LOTS 1 thru 7 and OPEN SPACE LOT 8

SUPPLEMENTAL PLANS

A RESUBDIVISION OF CEDAR ACRES BLOCK A, LOT 12 PLAT BOOK 4, FOLIO 11, 10932 HILLTOP LANE TAX MAP: 35 - GRID: 11 - PARCEL: 41 ZONED: R-SC

TITLE SHEET APRIL 16, 2018 BEI PROJECT NO. 2615

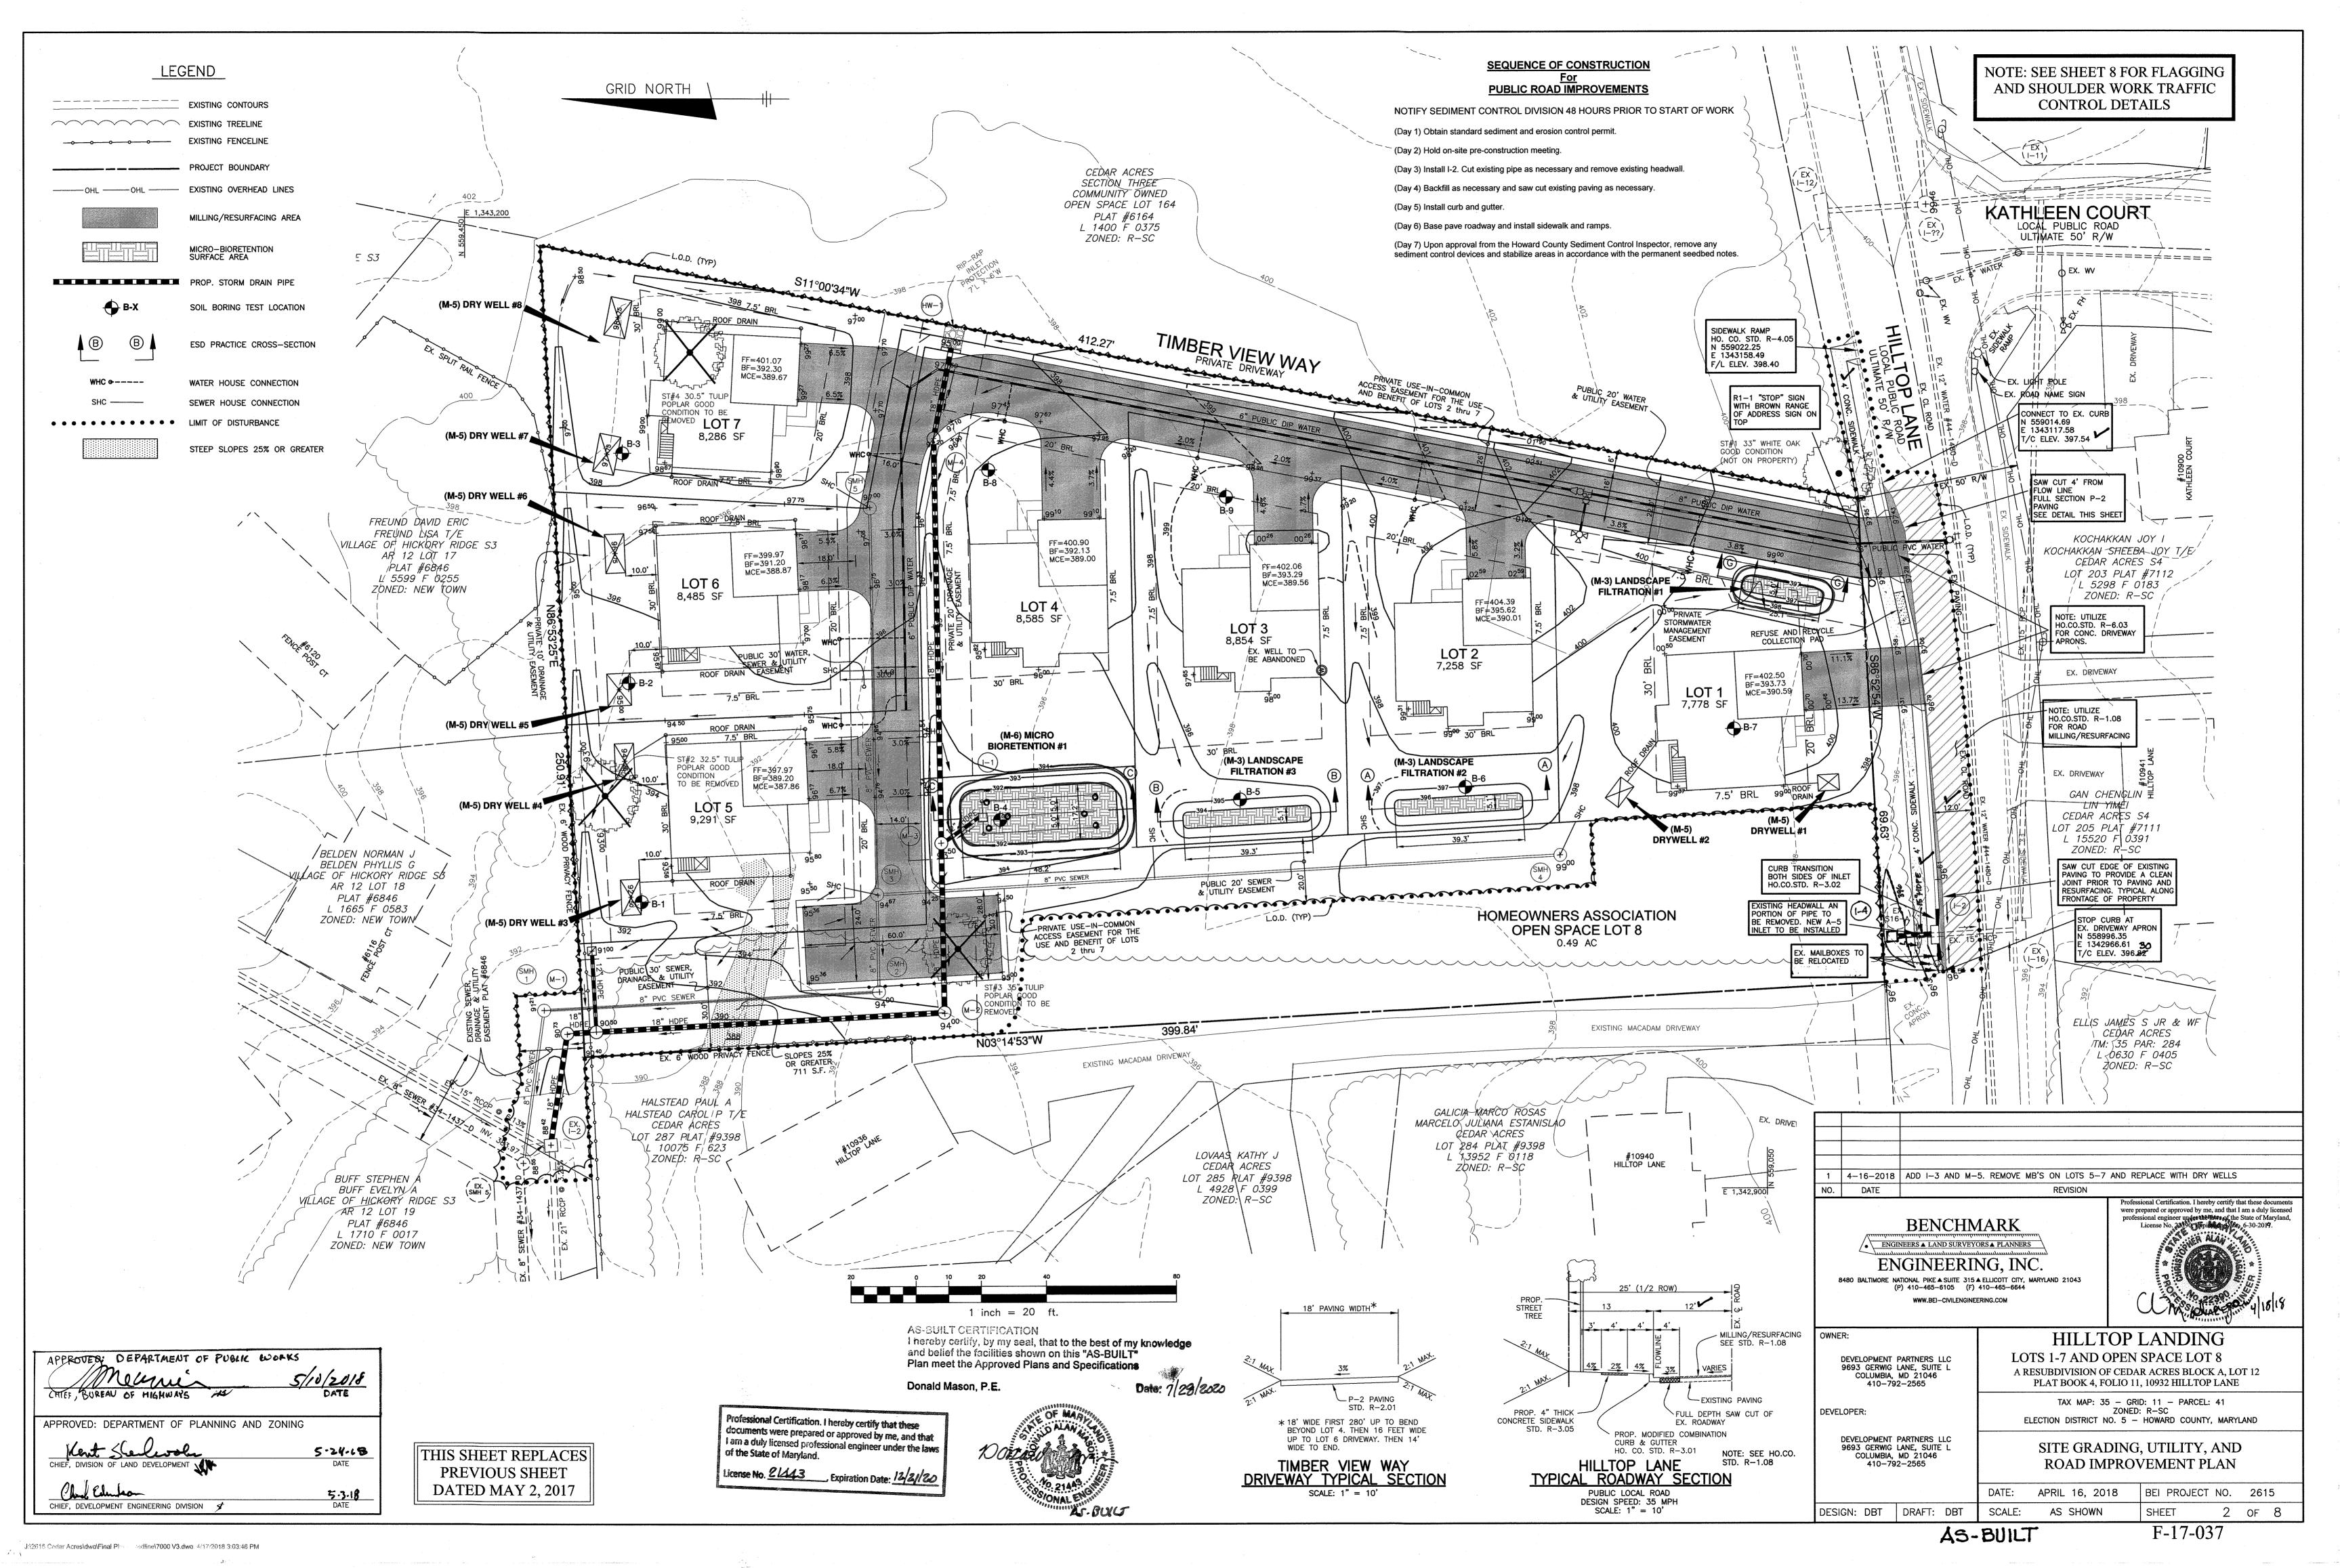
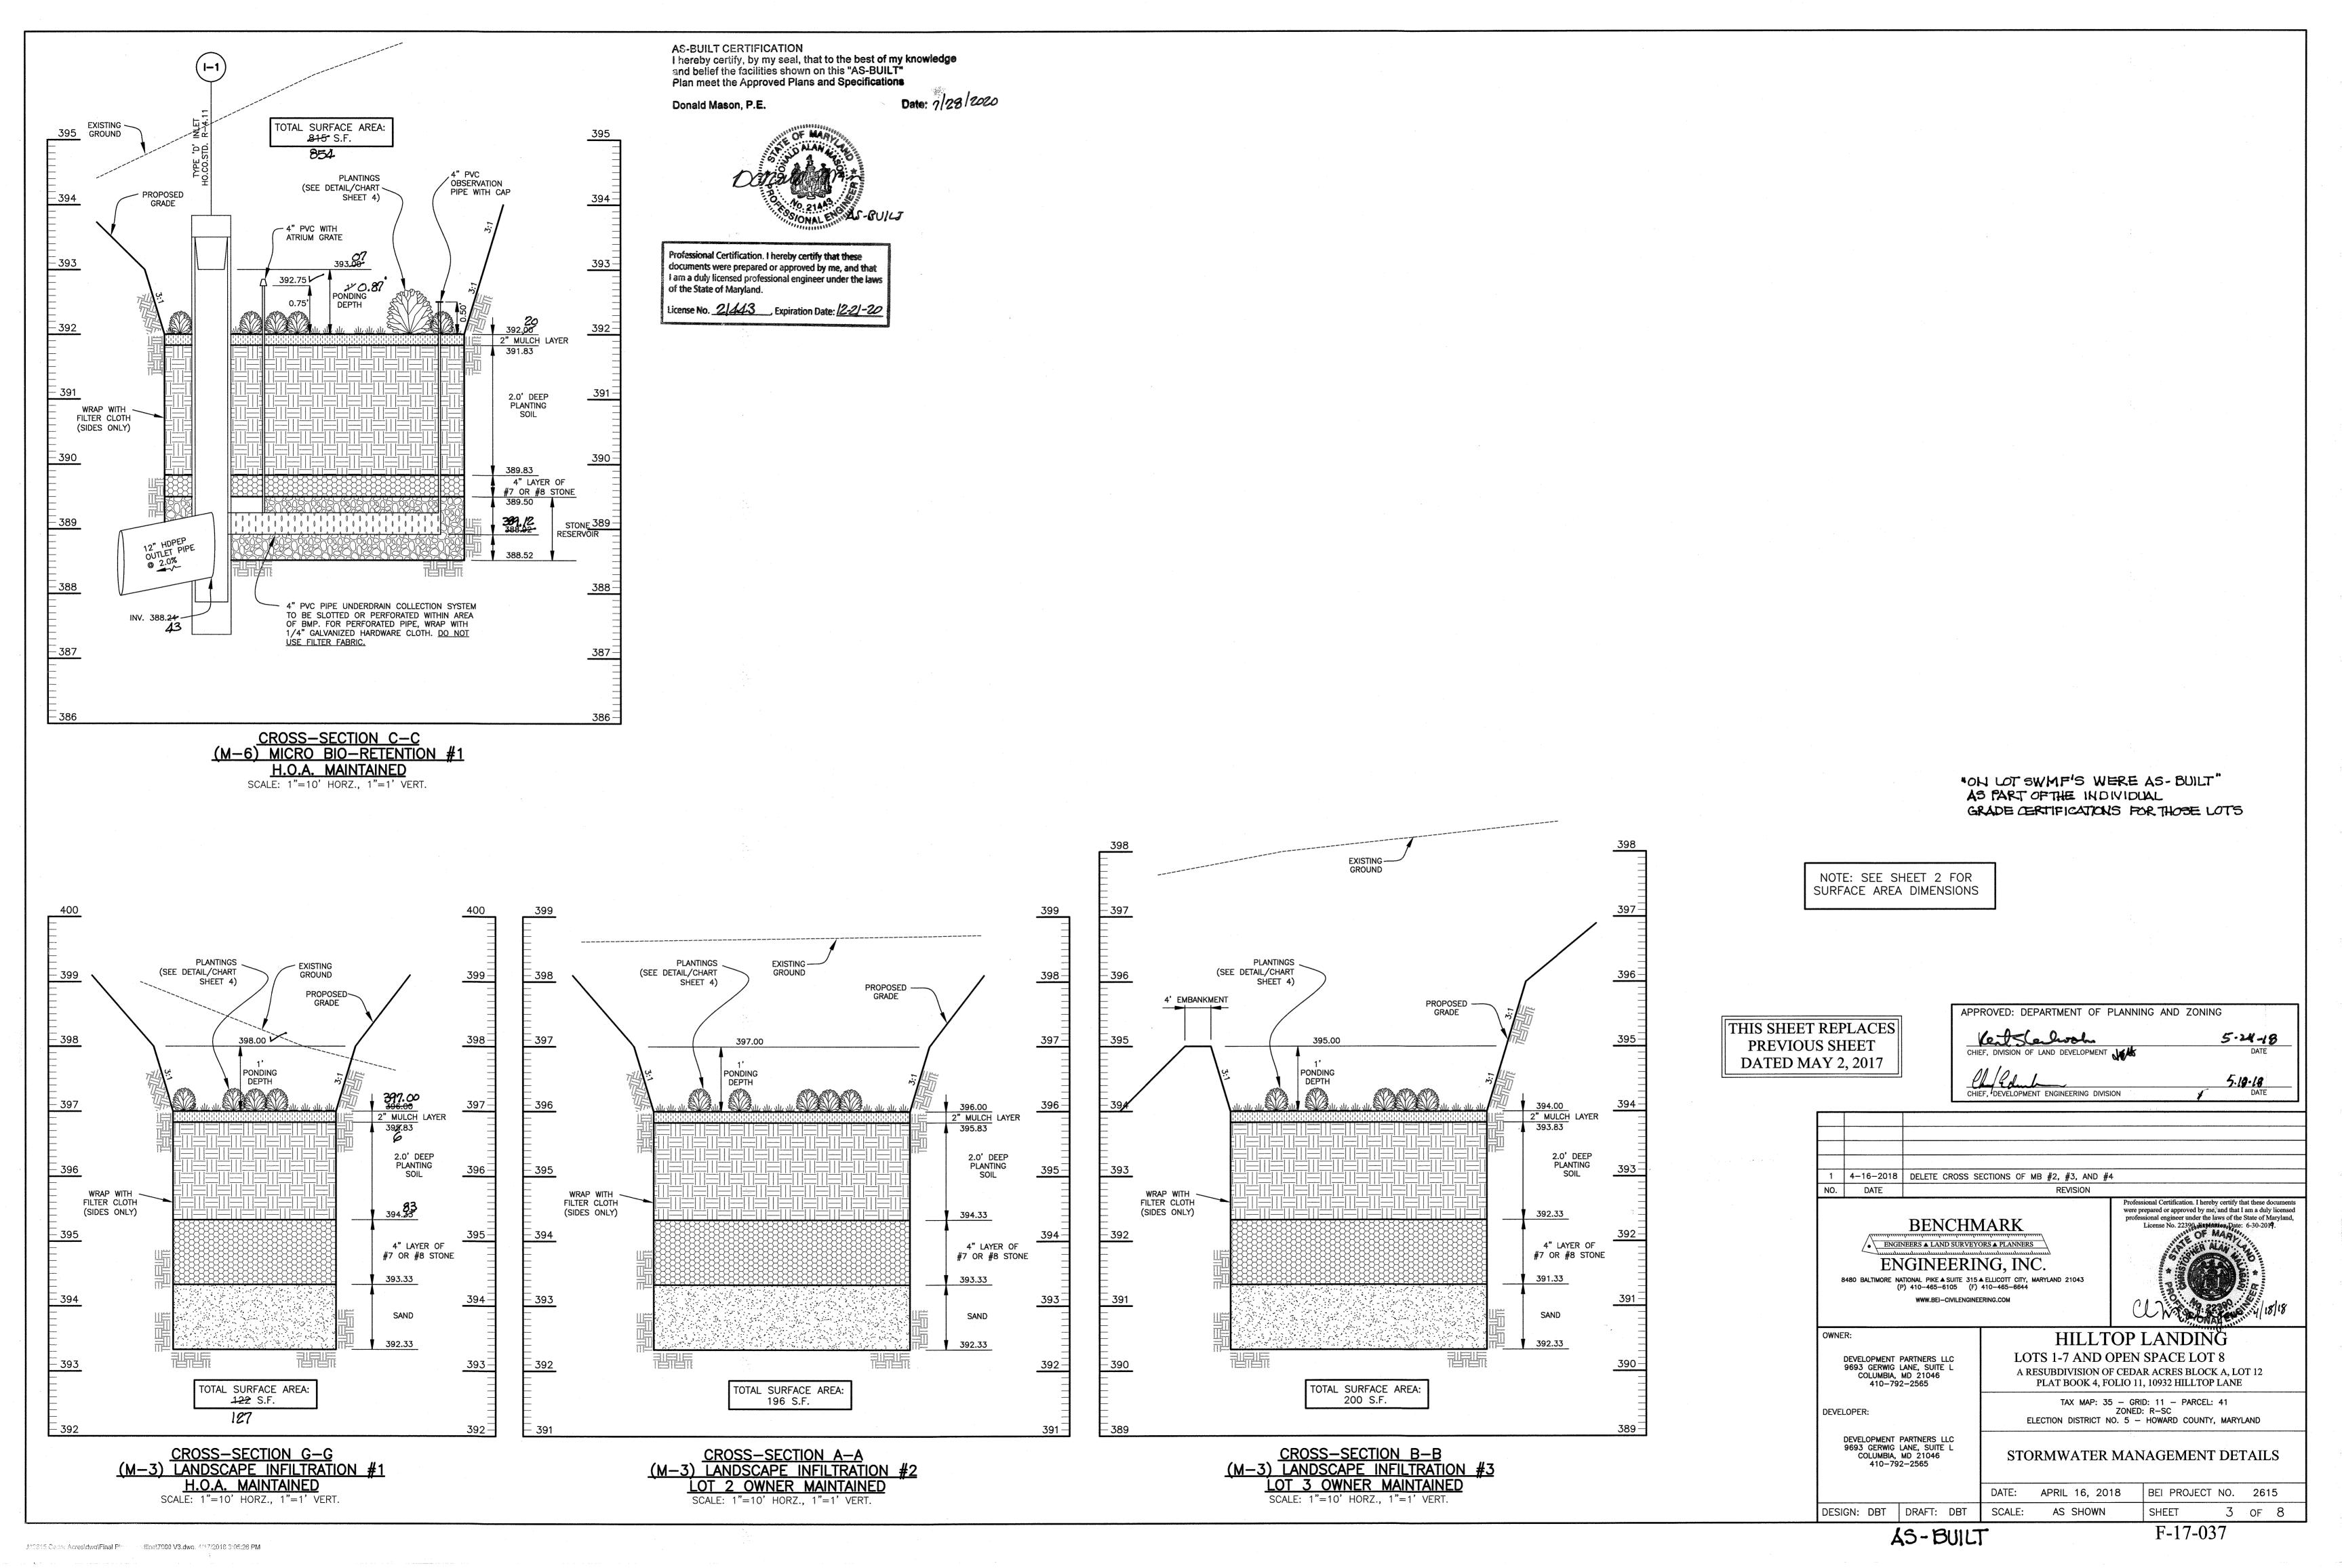
-	
1	4-16-2018	REVISE SWM SUMMARY TABLE				
NO.	DATE		REVISION		-	
		DENCHMADIZ		Professional Certification. were prepared or approved professional engineer und	by me, and that I am a	duly licens
